Subject: Oyster Creek Nuclear Generating Station
 Docket No. 50-219
 SEP Topic III-6 Seismic Design Considerations
 (Piping Evaluation)

GPUN letter dated July 1, 1985 transmitted Material Nonconformance Reports (MNCRs), marked-up support and isometric drawings for Control Rod Drive Return, Liquid Poison, Main Steam, Core Spray, Feedwater and Isolation Condenser system piping which were generated during our IE Bulletin 79-14 re-inspection effort. These six piping systems were reviewed under the Systematic Evaluation Program (SEP).

At a recent request of your staff, we are transmitting the MNCRs and marked-up drawings to you and Mr. M. Nitzel of EG&G, Idaho.

OYSTER CREEK
CORE SPRAY SYSTEM
MNCR'S
(INSIDE CONTAINMENT)

MNCR # 85-113-10
 ATTACHMENT
 TO MARKED
 UP DRAWING
 B.P. 200/R-1
 B.P. HGR # 461-R3

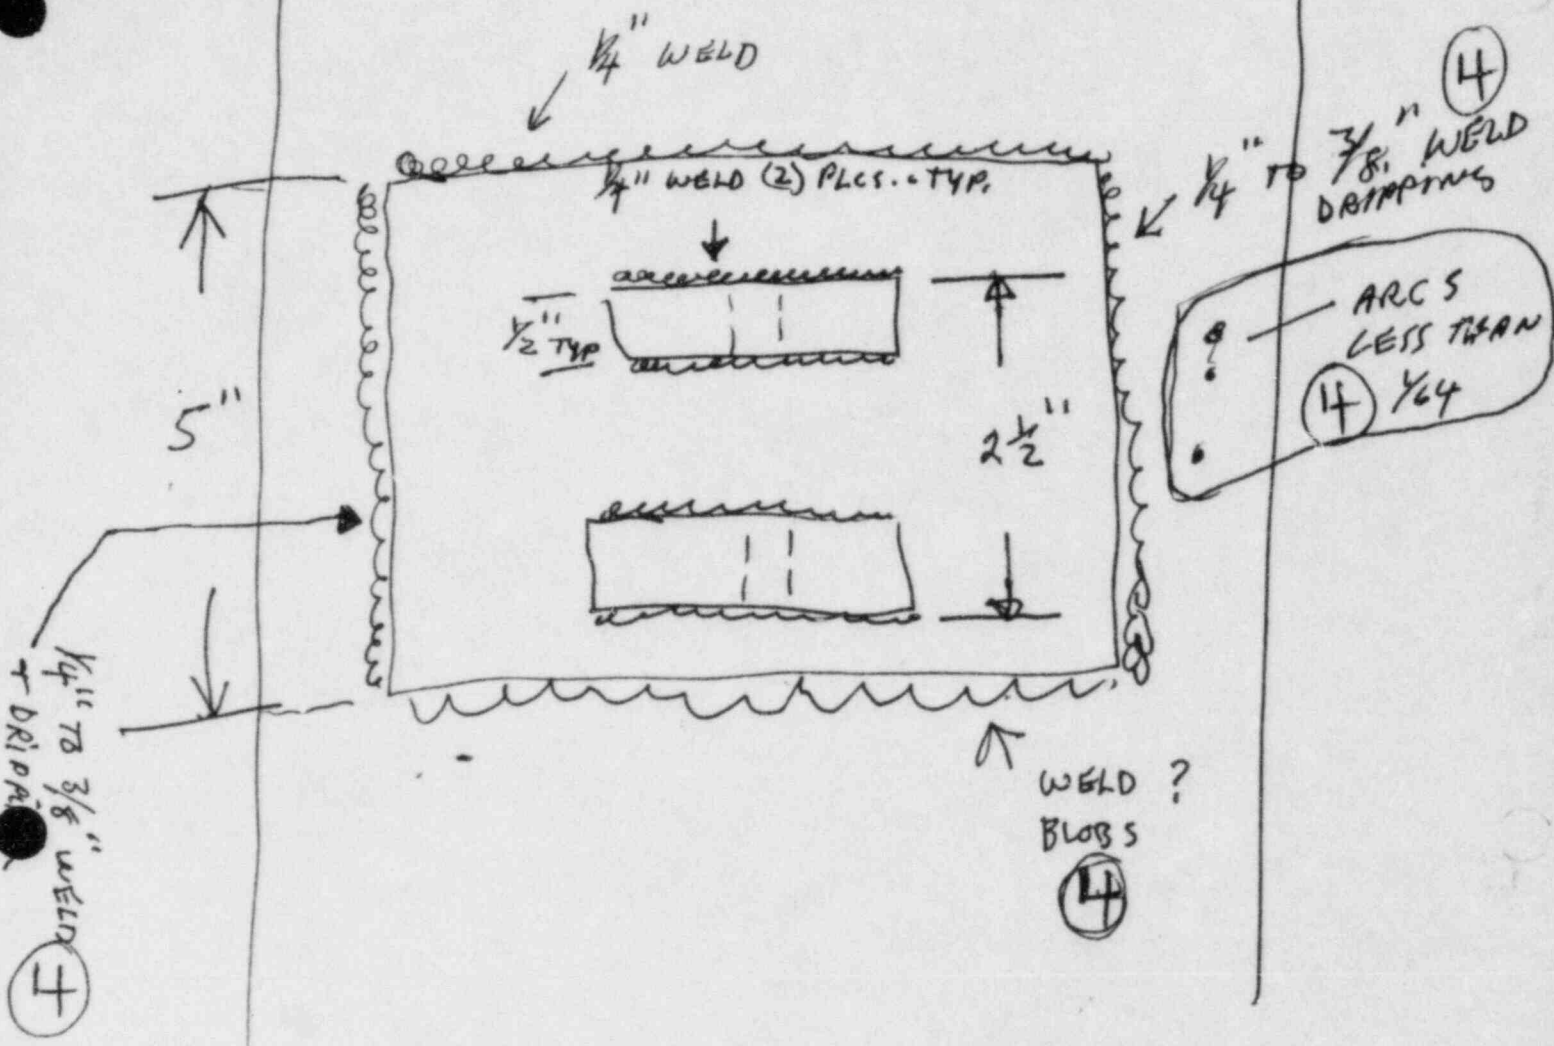
② AS FOUND CONFIGURATION OF SNUBBER NOT PER DESIGN DRAWING. (SPACER PLATE ADDED, TURNBUCKLE ADDED, THREADED ROD ADDED, BOLTS MISSING)

③ "LUG" FOUND WELDED TO PIPE AT BOTTOM AND WELDED TO PIPE CLAMP AT TOP, NOT AS SHOWN PER DESIGN DRAWING. (SEE AS FOUND SKETCH), WELDING NOT PER DESIGN DRAWING FOR PIPE CLAMP TO PIPE.

NEEDED FOR INSTALLATION STRUCTURALLY ACCEPT. CHANGE DWG.

~~ADD SAME LUG TO OTHER SIDE OF PIPE OR WELD CLAMP TO PIPE PER DWG. LUG IS WELDED TO PIPE AND CLAMP STRUCTURALLY ACCEPT. WELD. 10-25-85~~

REF. DWGS.
 BER-PAT INDEX:
 BER-PAT 150: 461
 GPC 150: JCP-19440 SHT. 10

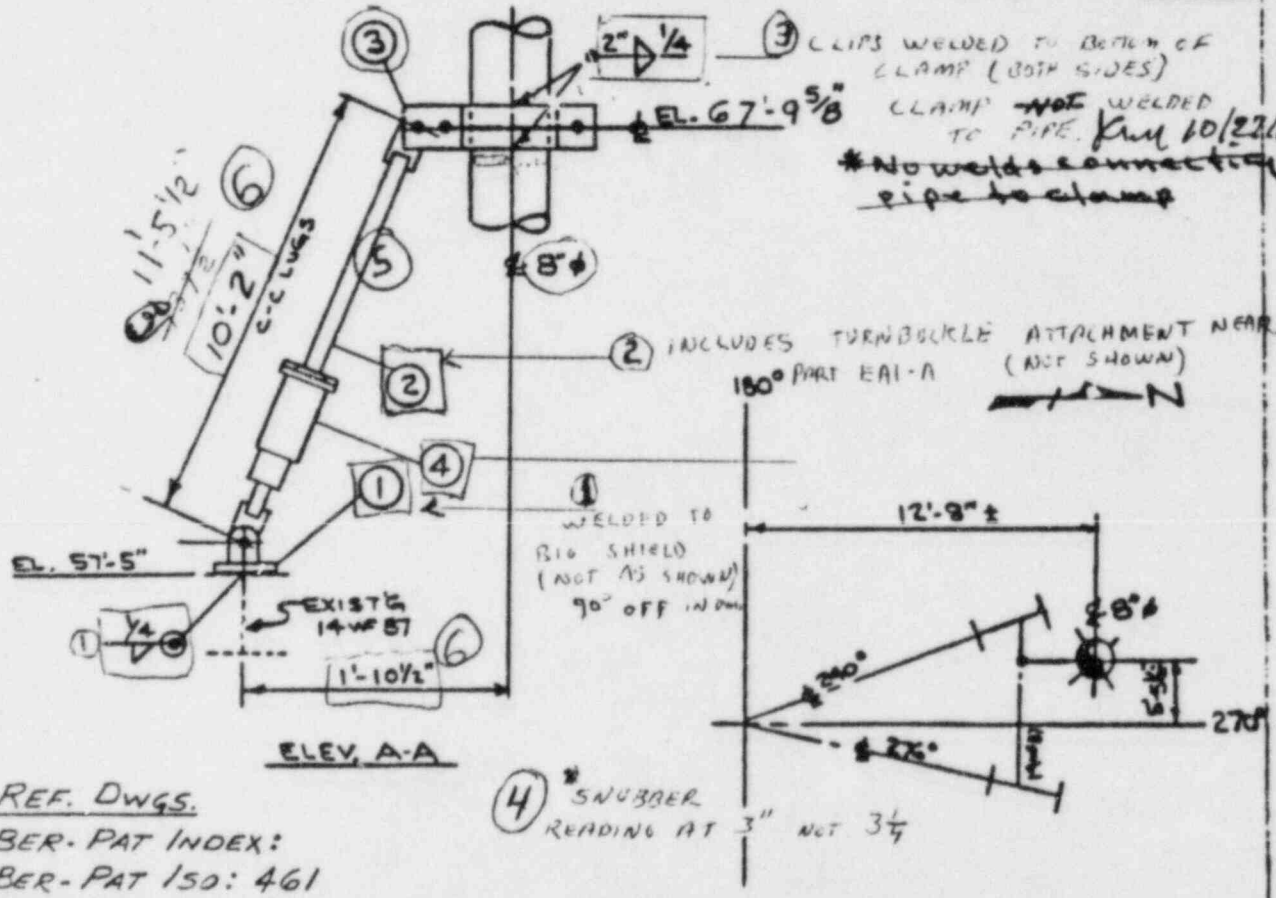
① CONFIGURATION OF WELDED BEAM ATTACHMENT DOES NOT CONFORM TO DRAWING WITH RESPECT TO ATTACHMENT LOCATION.

② CONFIGURATION OF SNUBBER ASSEMBLY DOES NOT CONFORM TO DRAWING. (TURNBUCKLE NOT SHOWN)

③ WELDING DETAIL, FOR PIPE CLAMP TO PIPE, WELD DOES NOT CONFORM TO DRAWING AS SHOWN. NO LUG DETAIL IS GIVEN

⑤ SNUBBER CONFIGURATION, AS FOUND IN FIELD, IS REVERSED WITH "SNUBBER" INSTALLED OPPOSITE AS SHOWN ON DRAWING.

⑥ DIMENSIONAL MEASUREMENTS AS FOUND IN FIELD, VARY WITH THOSE AS SHOWN ON DESIGN DRAWING FOR PIN-TO-PIN ON SNUBBER AND ϕ OF PIPE TO ϕ OF WELD BEAM ATTACHMENT.

CHANGE DWG.

CHANGE DWG.

DIMENSIONAL DISCREPANCIES DO NOT AFFECT STRUCTURAL INTEGRITY
CHANGE DWG.

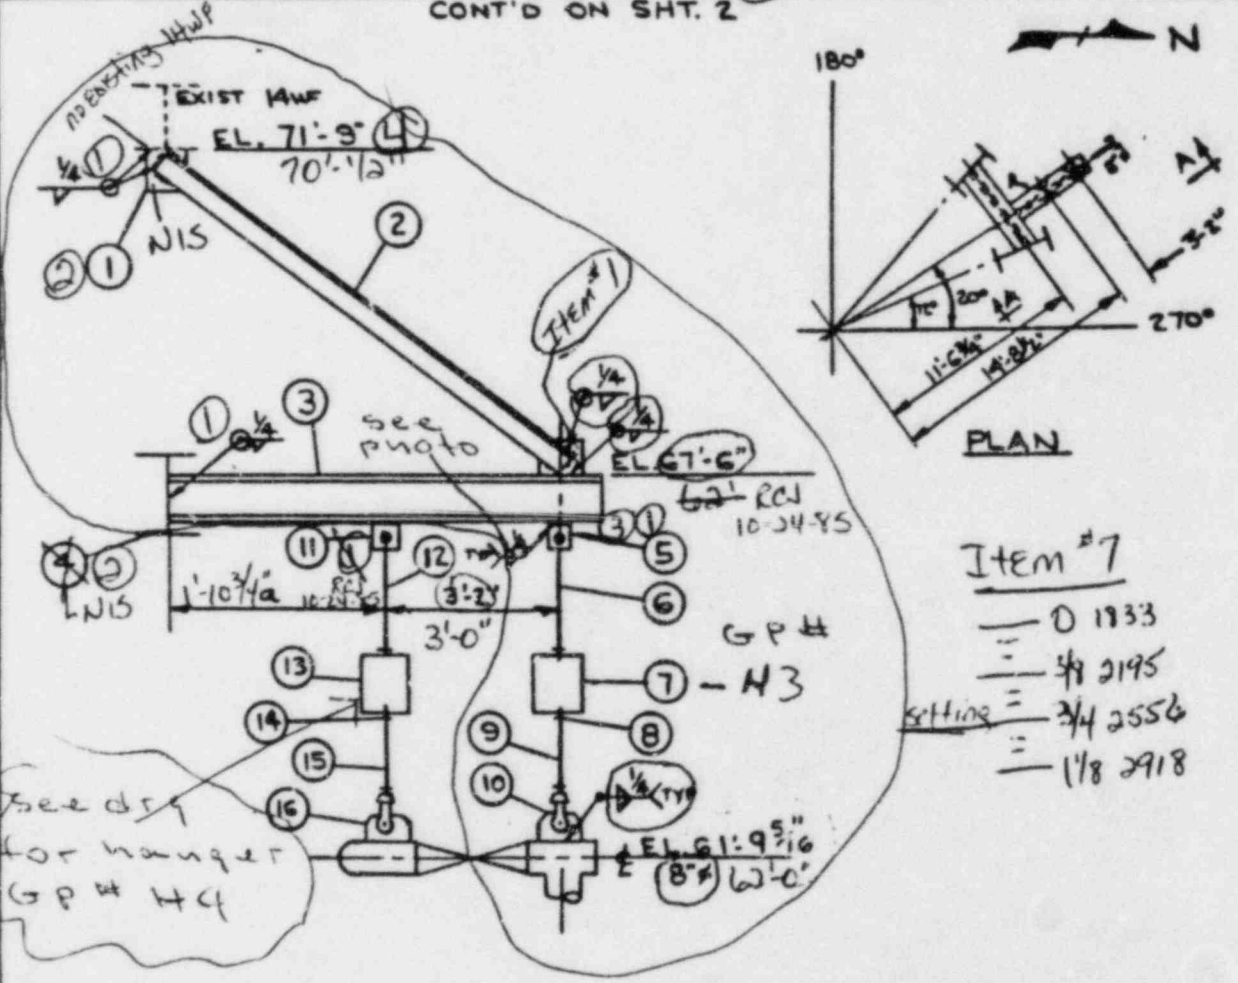
FOR WELD INFO SEE
MNCR 85-113-15
WELD IS ACCEPT.
CHANGE DWG.

WELDED TO 14WF DIRECT.
SEE MNCR 85-113-15 FOR WELD $\frac{1}{2}$ WELD
SIZES.
STRUCTURALLY ACCEPT.
CHANGE DWG.

FULL PENETRATION BUTT WELD IS ACCEPT.
CHANGE DWG. TO "AS BUILT"

ELEVATION DISCREPANCY HAS NO STRUCT.
IMPACT. — ACCEPT.
CHANGE DWG.

LENGTH OF ROD IS "AS BUILT" AND
STRUCTURALLY ACCEPTABLE.
CHANGE DWG.

Subject		Calc No.	Rev. No.	Sheet No.
Originator		Date	Reviewed by	59 of
			Date

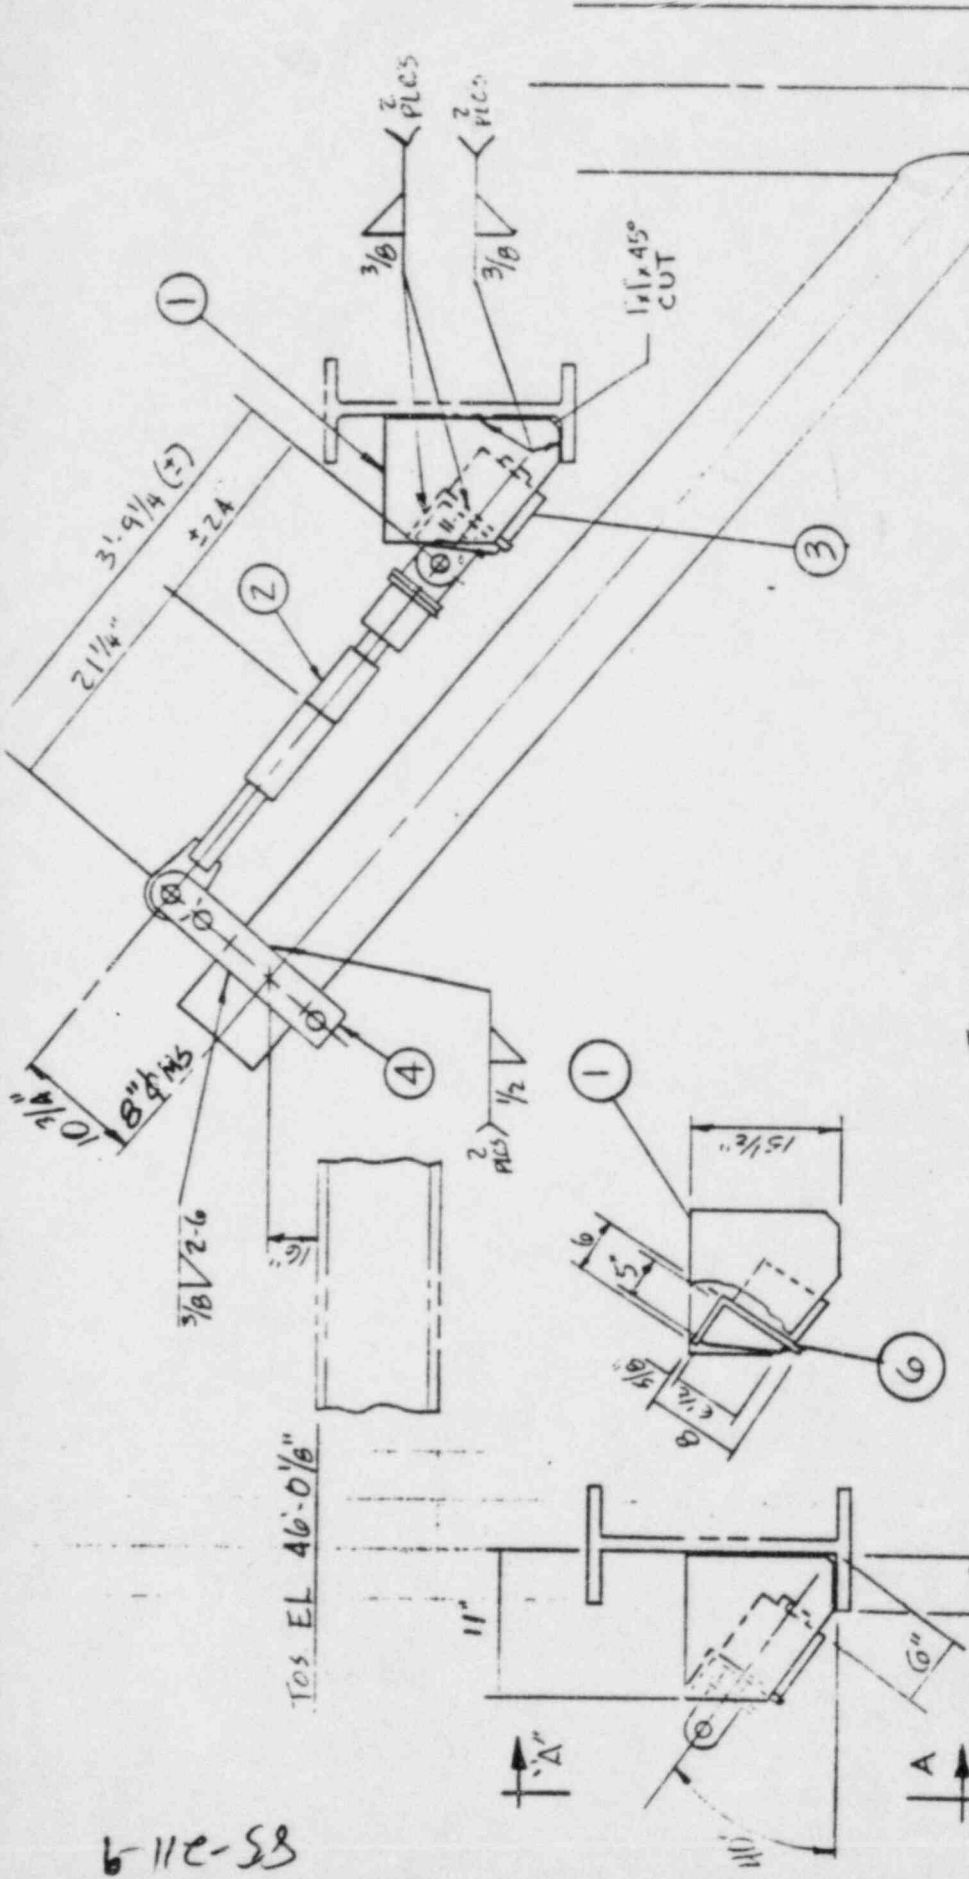
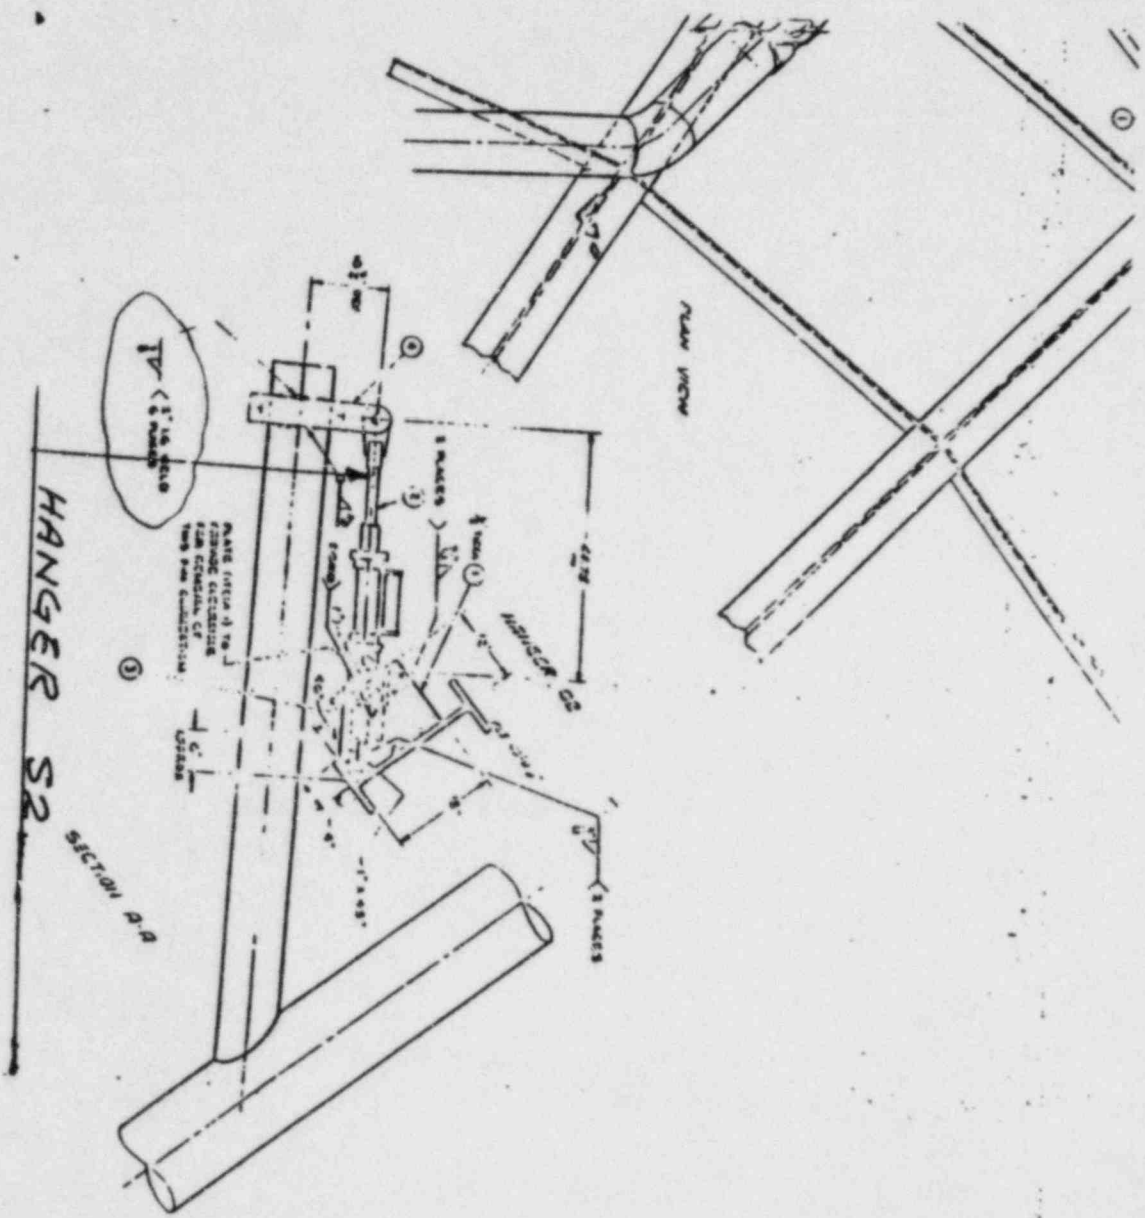
PLEASE PROVIDE DETAILED DETAILS FOR SNUBBER CLIP
 ATTACHED TO ANGLE IRON, LOCATED BETWEEN TWO (2) 1/2"
 RAILS (ITEM # (1) ON B.O.M.) 10K SUPPORT # (B.P.) S2, AS
 SHOWN ON THE MOUNTING SKETCH MPR-1083-14-6, SHEET 60c
 (ORIGINAL AS ITEM # (4) ^{CHSKT ICH} DOCUMENTED AS ITEM # (4) ON MNCR #
 85 211 9)

1 - ARC STRIKES - (2) APPROX. 1" LG.
SEE SHEET 60C ON STRUCTURAL MEMBER
LESS THAN 1/64" DEEP

2 - (4) 1/2" BOLTS MISSING ON SNUBBER
SEE SHEET 60C. NOTE - 1" THICK SPACER
PLATE EXISTS WITH FOUR (4) 1/2" BOLTS
THRU SPACER PLATE TO UNDETERMINED DEPTH
(SEE SKETCH)

3 - WELDING LENGTHS - NO. OF WELDS.
SEE SHEET 60D
